## HISTORIC AND DESIGN REVIEW COMMISSION

March 01, 2017

**HDRC CASE NO:** 2017-075  
**COMMON NAME:** 307 PEARL PKWY  
**LEGAL DESCRIPTION:** NCB 14164 BLK 1 LOT 4 (RIO PERLA DEVELOPMENT)  
**ZONING:** IDZ RIO-2 HS  
**CITY COUNCIL DIST.:** 1  
**LANDMARK:** Commercial Building  
**APPLICANT:** Jason Moran /Richard Mogas Architecture  
**OWNER:** Rio Perla Properties, LP  
**TYPE OF WORK:** Construction of a accessory structure, signage  
**REQUEST:**

1. Construct a storage structure at the rear of the Pearl Stable. The proposed unit will have a footprint of approximately 462 square feet and will be constructed to match the existing materials found throughout the Pearl including board form concrete walls and a painted steel awning.
2. Install a wall mounted sign on the east facing façade to be lit by wall mounted spot lights.

**1 FLOOR PLAN**  
1/8" = 1'-0"

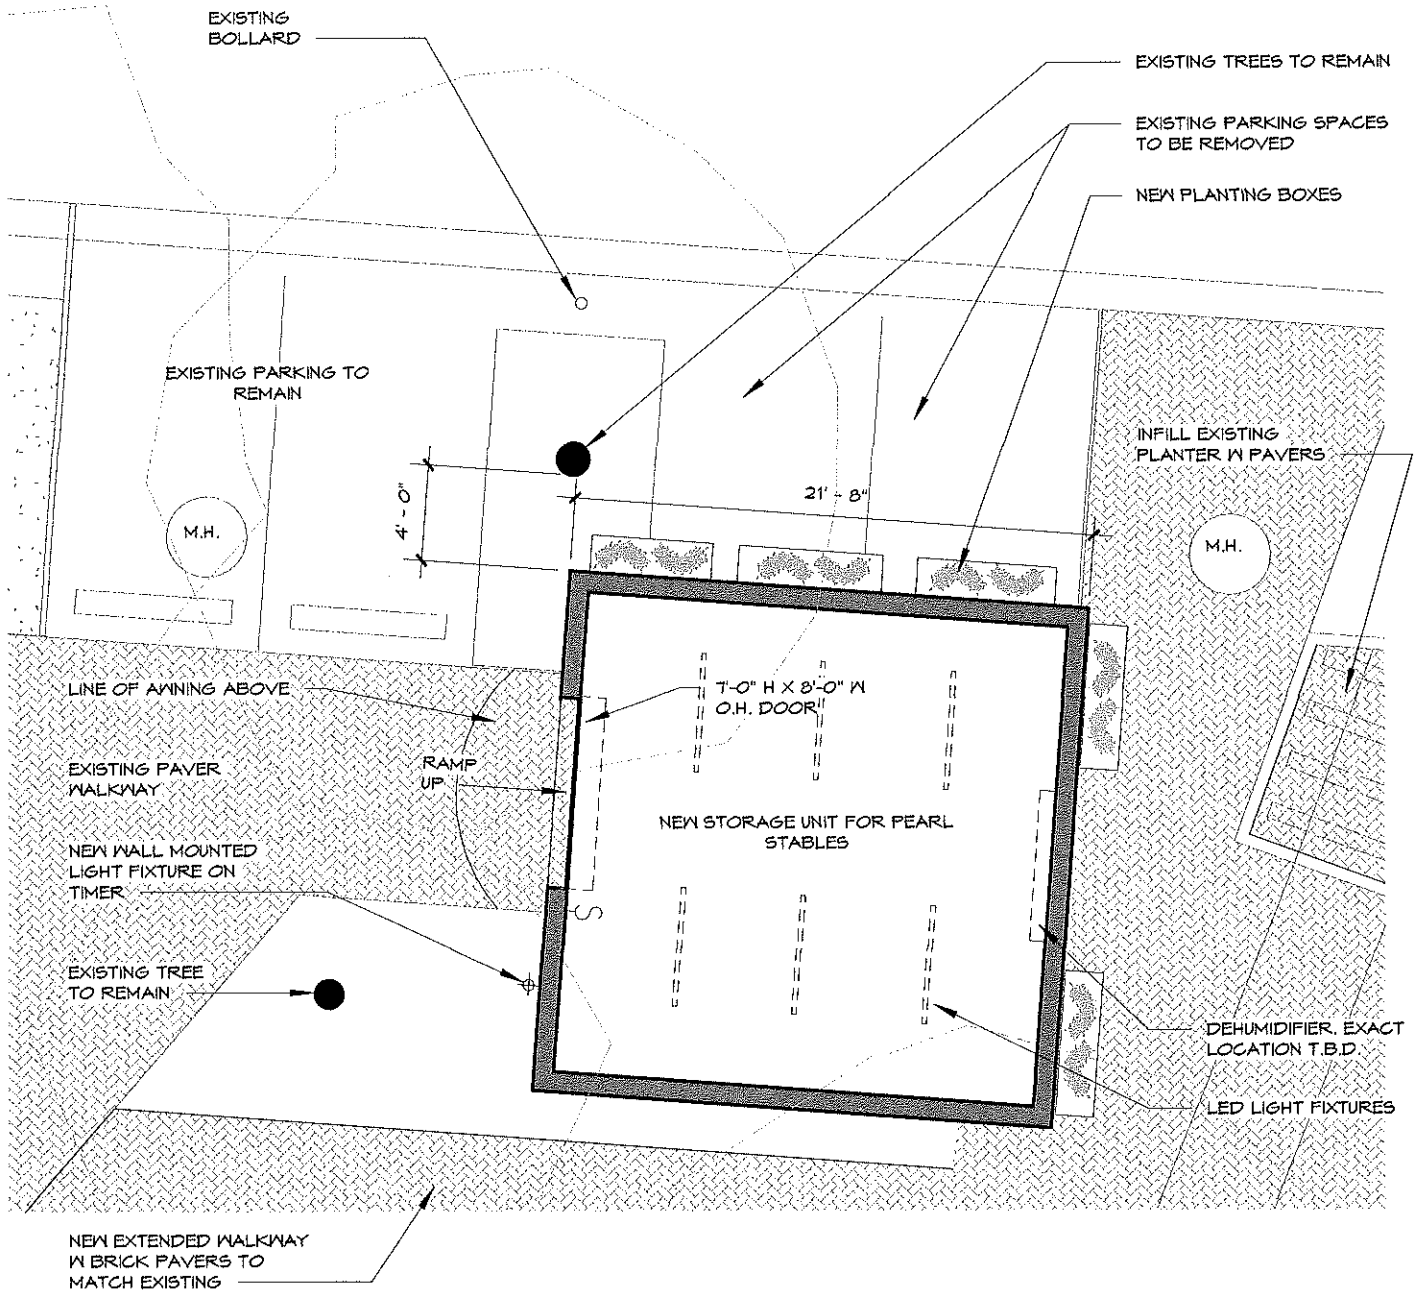
- a. The applicant has proposed to construct a new storage structure to serve as a secondary storage location for the Pearl Stable. The storage unit will feature an overall footprint of approximately 462 square feet. The applicant has proposed for the structure to feature signage on the north wall facing Avenue A.

- b. PEDESTRIAN CIRCULATION – Per the UDC Section 35-672(a), pedestrian access shall be provided among properties to integrate neighborhoods. Additionally, the various functions and spaces on a site must be linked with sidewalks in a coordinated system. The applicant has proposed to extend the existing brick paver walkway around the location of the proposed storage structure to improve pedestrian access across the site. This is consistent with the UDC.

- c. LANDSCAPE DESIGN – Regarding landscape design, the applicant has proposed to maintain existing site trees, remove two existing automobile parking stalls, install new planting boxes and infill one existing planter with brick pavers. Staff finds this appropriate and consistent with the UDC.

**1 NORTH ELEVATION**  
3/16" = 1'-0"

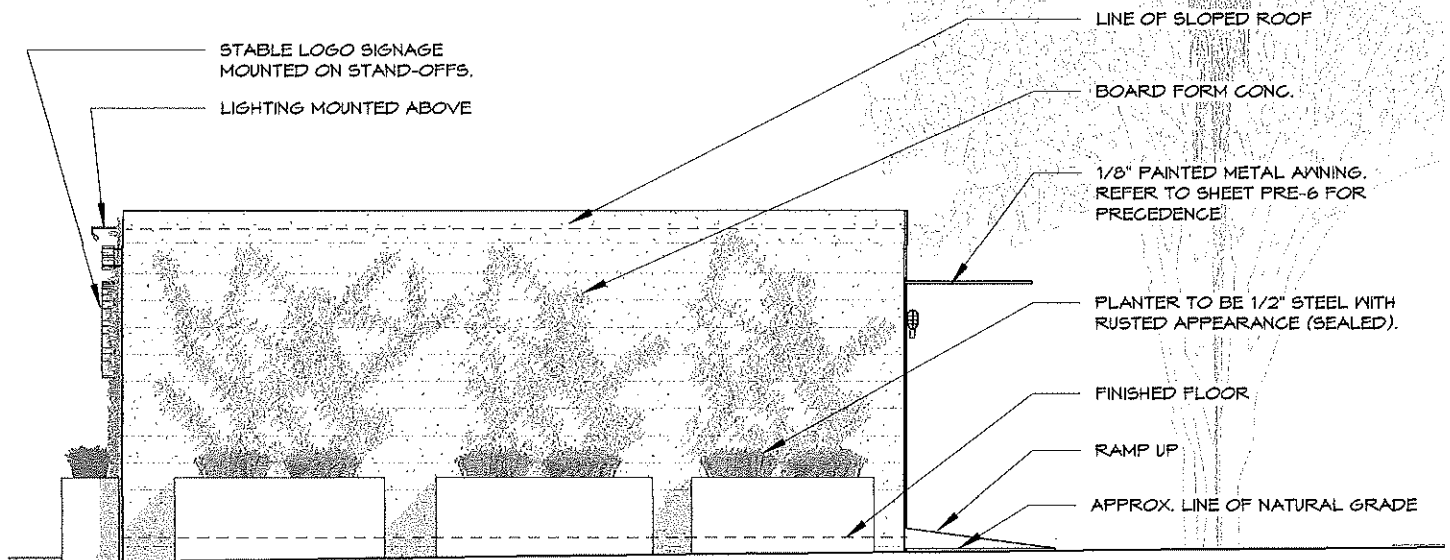
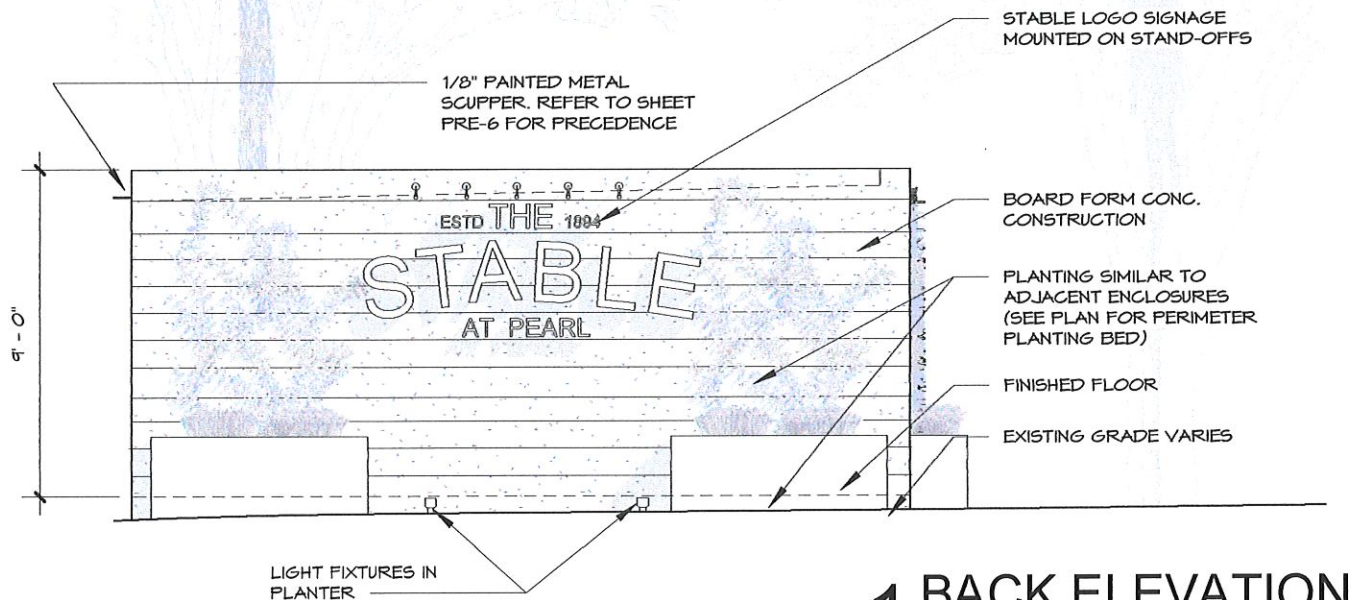
- d. LIGHTING – The applicant has proposed to install wall lighting on the proposed storage structure. Staff finds the installation of the proposed lighting appropriate for the location.

- e. MATERIALS – The applicant has proposed materials that are to include board form concrete, steel planter boxes, a painted metal awning, a metal overhead rolling door and a flat roof. The proposed architectural materials are consistent with those of new construction found in the immediate vicinity of the proposed new construction. The proposed materials are appropriate and consistent with the UDC.

## 2 SIGNAGE DIMENSIONS

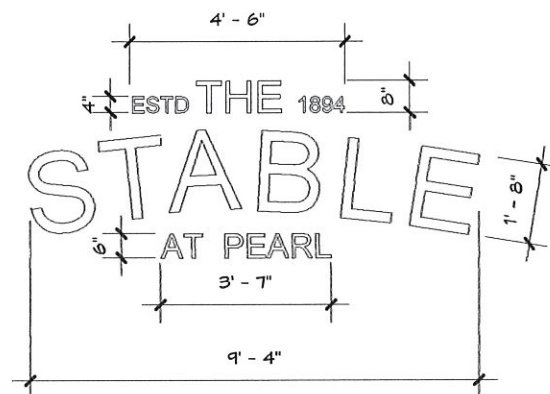
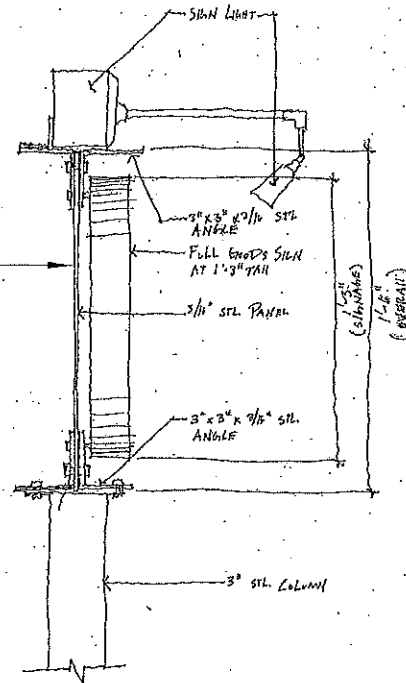
- f. SIGNAGE – The applicant has proposed to install wall signage to read “The Stable at Pearl” and “Estd 1894” on the Avenue A façade of the proposed storage structure. The applicant has proposed an overall size of approximately twenty-one (21) square feet. The applicant has proposed for the signage to be indirectly illuminated by wall mounted spot lights. The original application did not specify a material for the proposed signage; however, the applicant has proposed metal. Staff finds this appropriate.

Staff recommends approval of items #1 and #2 based on findings a through f with the following stipulations:

- i. That the applicant install signage that is constructed of metal lettering.
